**SUMMARY OF CHANGES TO ITS SECTION 3.0 - REVISION D**

# **JAFNPP IMPROVED TECHNICAL SPECIFICATION (ITS)**

## **CONVERSION PACKAGE**

### **Section 3.0**

INSERT B 3.0-3

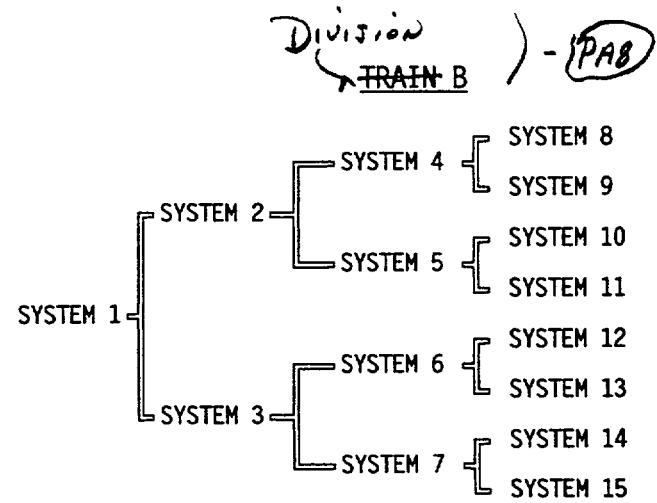
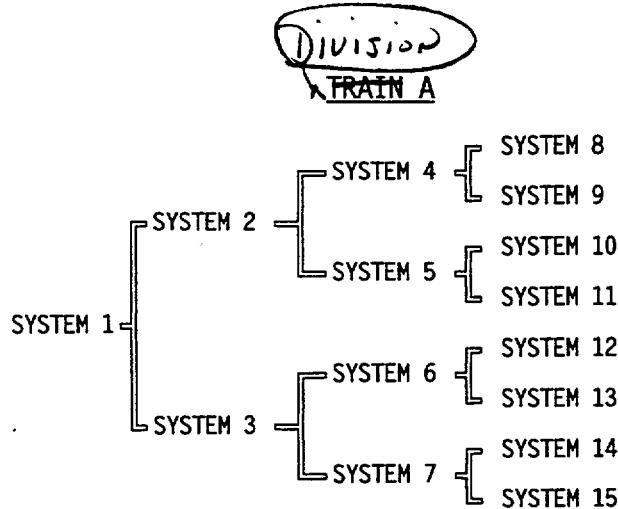
TAI
